# THORNHAUGH MEWS PROJECT

Addendum to Design & Access Statement  
October 2016

for  
University College London

Rev 04: 14/10/16

Figure 5: Equivalent view of stepped spur

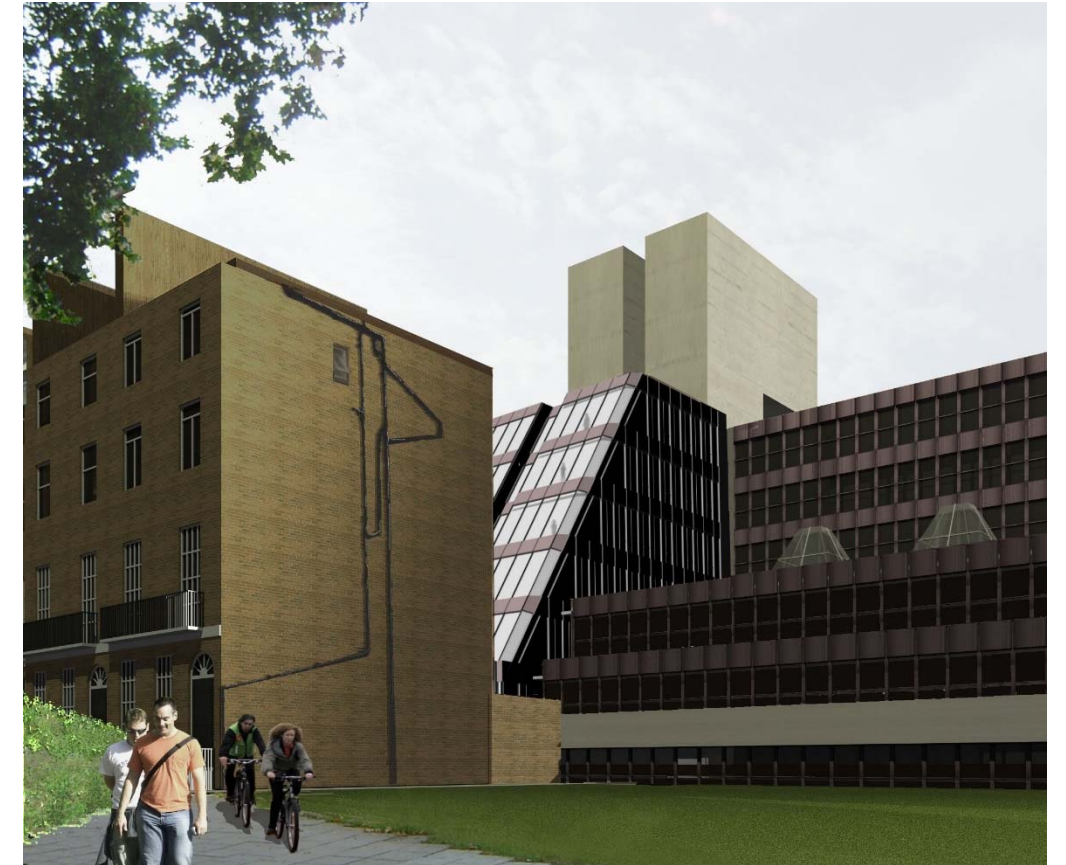
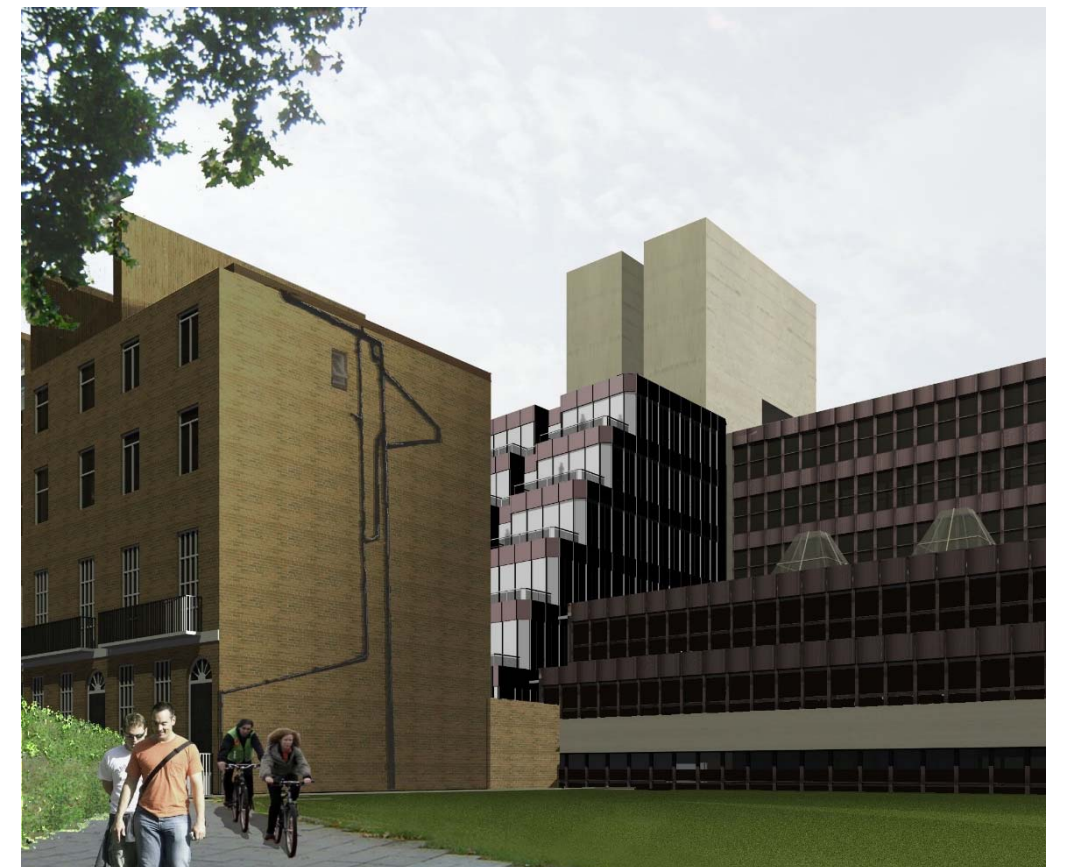
It is proposed to amend the new spur extension to provide a stepped profile with terraces to the south-west elevation at each level rather than a sloped glazed profile. Both stepped and sloped options for the south-west elevation were considered originally and it was felt that both would be viable, in principle, in terms of the context and character of the existing buildings. However, IOE's preference at the time was for the sloped version, principally because this would provide additional space and would avoid new external terraces at upper levels, which they anticipated would be difficult to manage and maintain. UCL have reviewed this decision and have confirmed that they would prefer a stepped profile and that they are able to maintain these external areas. A further significant benefit of the stepped profile is that it would improve energy performance which would help to meet regulations that have become significantly more onerous since 2009.

The change to a stepped profile would align the appearance of the new spur block more closely with that of Lasdun's only built spur, while its massing and the detailed design of the elevations, otherwise unchanged from the consented and implemented scheme, would continue subtly to distinguish it from both phases of Lasdun's work. This would make the extension sit more comfortably into the framework of the Lasdun building, and thus be marginally beneficial in terms of its effect on the character and appearance of the grade II\* listed building. The slight reduction in enclosed volume would similarly be marginally beneficial in relation to the setting of the back of the Grade II listed terrace in Woburn Square. For both these reasons the amendments would also have a marginally beneficial effect on the character and appearance of the Bloomsbury Conservation Area.

Figure 7: Roof plan as proposed with stepped profile to spur forming terraces, reinstated cantilever and amended stair.

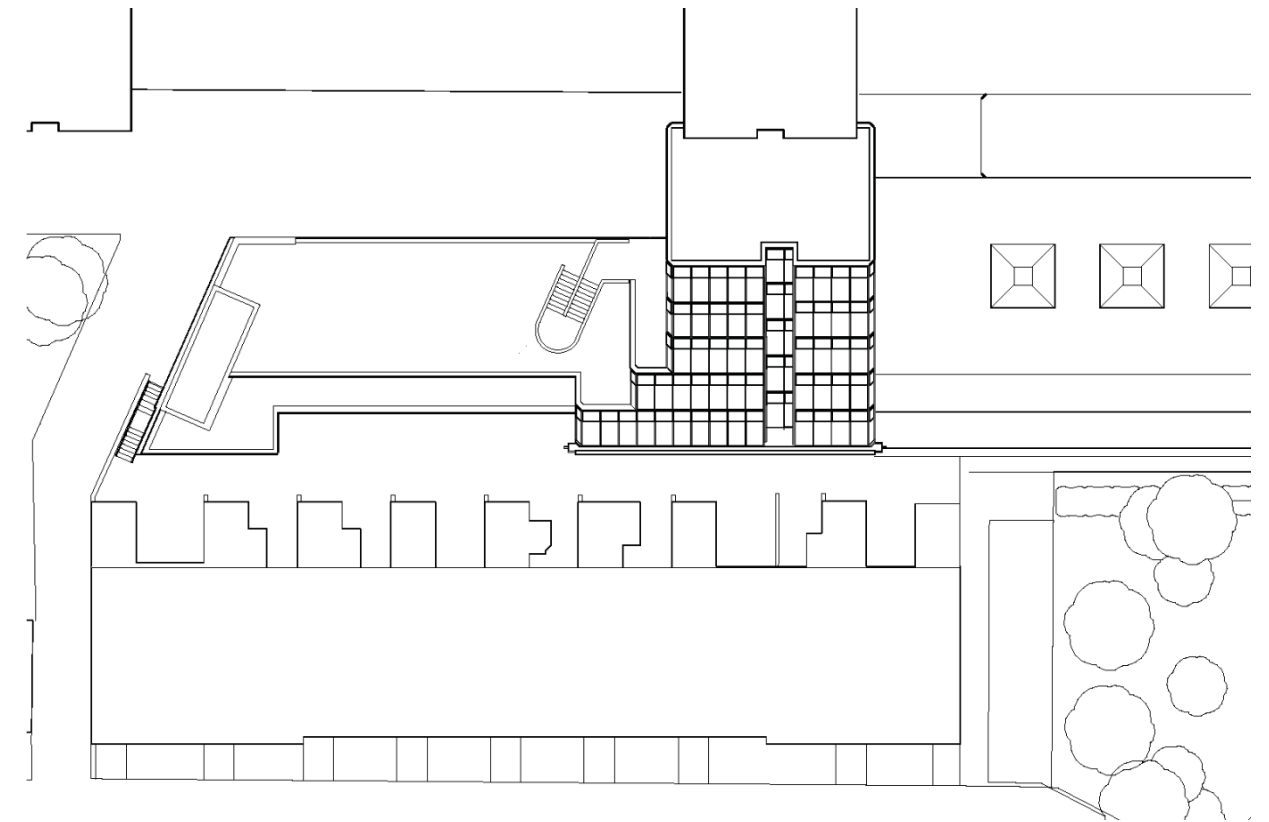
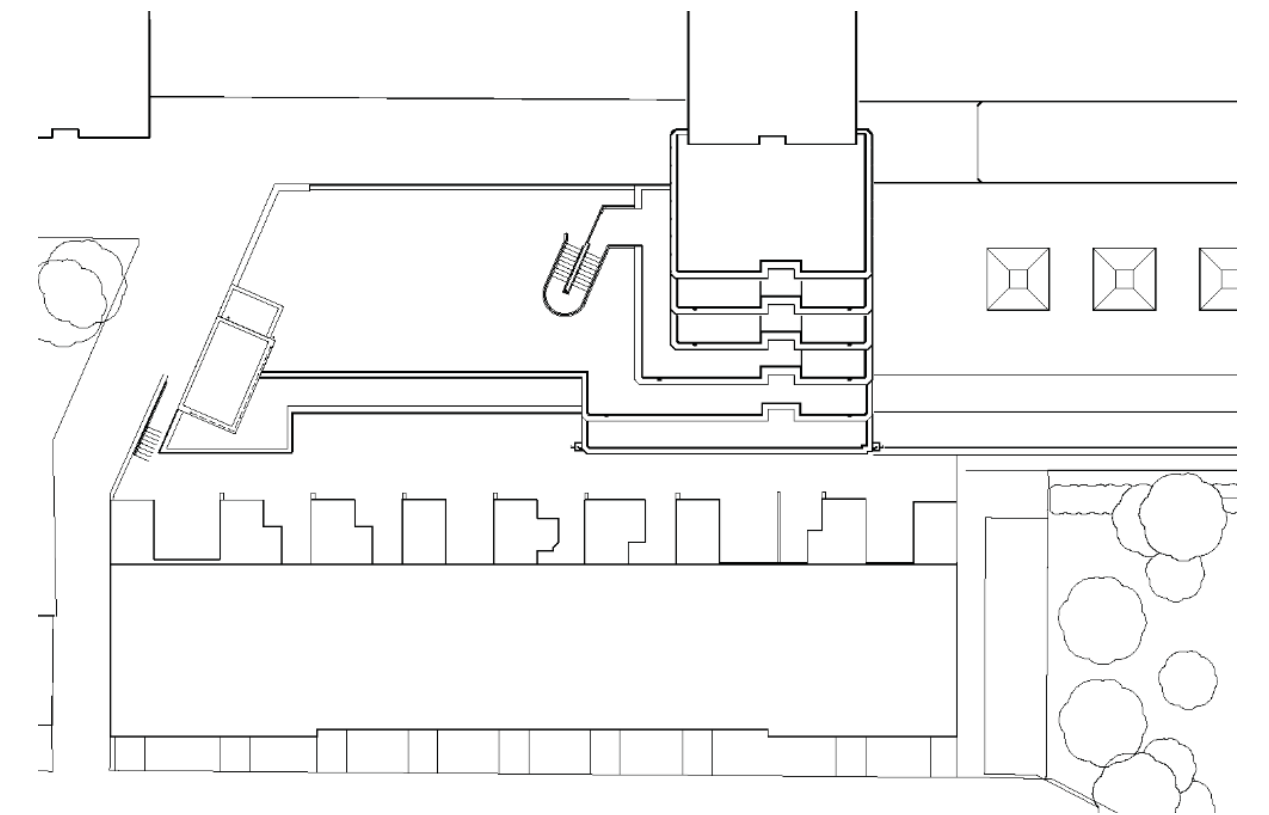
In the new mews building it is proposed to reintroduce a cantilevered portion of building over the service road.

This was a part of the original design that was discussed with Camden and other consultees in 2008. It was removed prior to submission following concerns raised by the adjoining owner. Now that the building is all under one ownership, this concern no longer exists and UCL intends to reinstate the cantilever to provide additional space.

The proposed projection of the cantilever (and thus the separation from the Bedford Way block of Lasdun's original, early 1970s, building) will exactly match that of the adjoining library, designed by Lasdun as an extension to the Institute in 1992-3. Reproducing that relationship in this second mews building to be added alongside the Bedford Way block will bring it into conformity with Lasdun's own thinking about the way in which his building should develop, and contribute to the sense of order in the overall plan. The effect on the character and appearance of the grade II\* listed building will therefore be positive. There is no effect on the setting of other listed buildings or on the conservation area, since the changes will only be visible from within the building itself.

The new staircase located at the northern end of the new mews building was originally designed to suit office and library accommodation. The new proposed use as teaching accommodation requires a slightly wider stair. As a result, the projecting stair tower increases in width by 400mm, which the design concept can accommodate.

We have also noted that the originally approved drawings contained an anomaly in the way that the stair core was shown. Some elevations showed the lift enclosure extending to the 6<sup>th</sup> floor, whereas in fact it only serves up to level 5. It is only the lift over-run that extends up to level 6 and this is concealed below the parapet to the roof, which reduces the overall bulk of the projecting enclosure. The relevant corrected drawings are included with this application.

Figure 9: Level 6 roof plan as proposed with reinstated cantilever, amended stair and terrace in lieu of sloped glazing

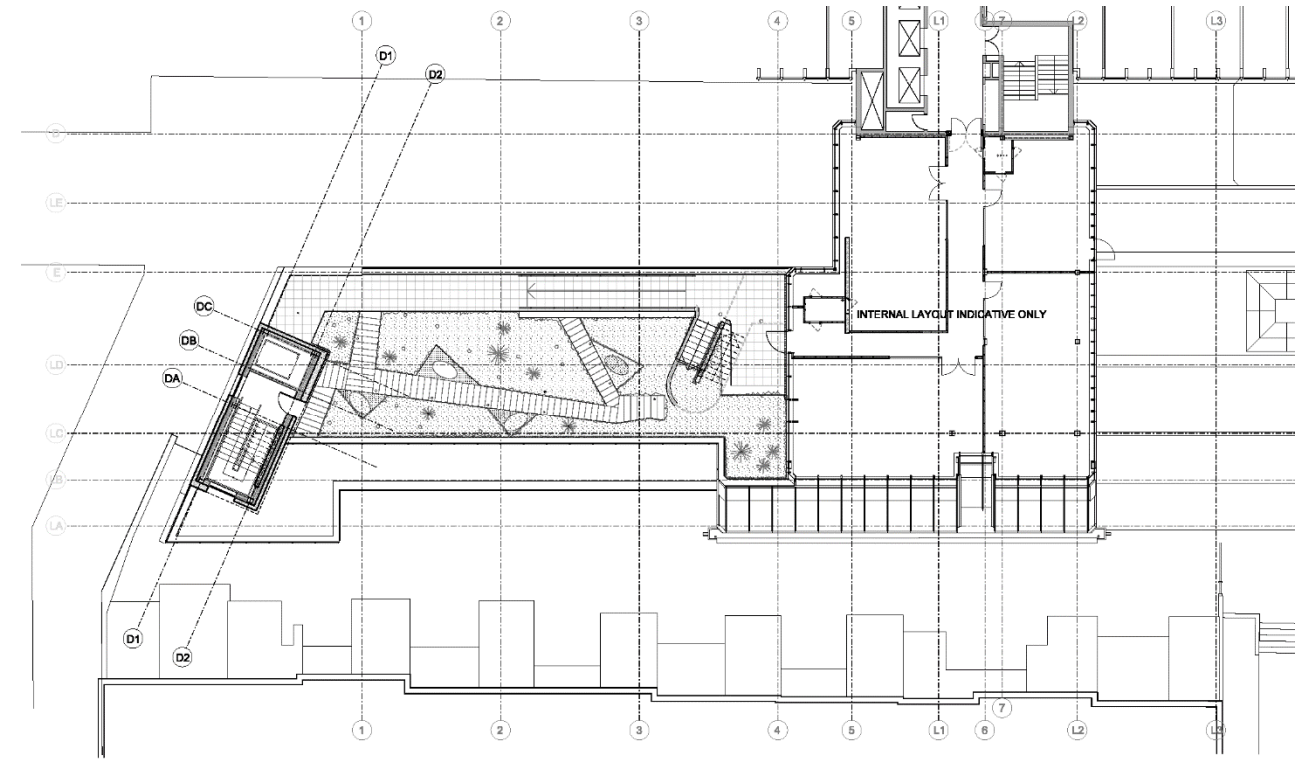
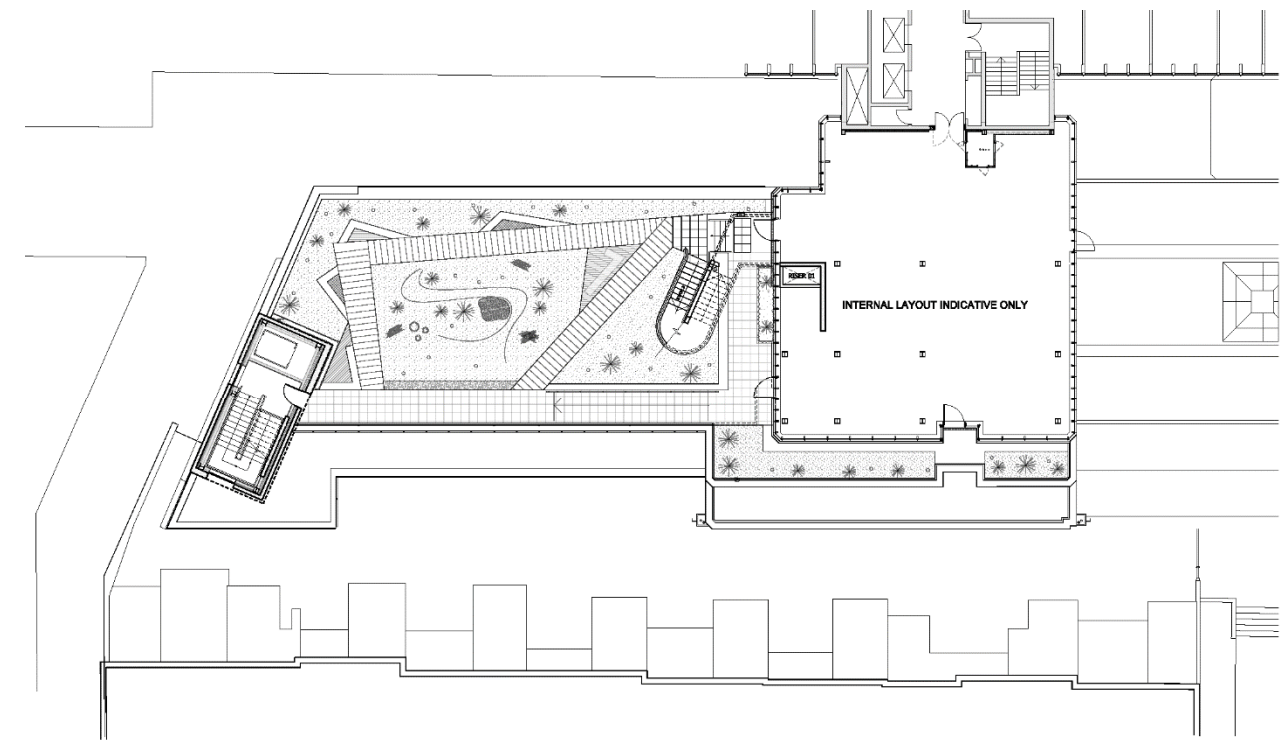
The change in profile of the new spur has resulted in a new series of external terraces at level 6 (library roof level) and levels 7, 8 & 9 over. It is proposed that these are planted as far as possible with a narrow maintenance strip against the windows. They will be accessible only for maintenance, but will be clearly visible and enjoyable from the interior spaces.

The reintroduction of the cantilever has increased the main area of green roof at level 6, back to what it was prior to removal of the cantilever.

All planted areas will be of “intensive” type with a soil depth of around 300mm. Measures to enhance biodiversity will be included in line with London Borough of Camden’s current design guidance.
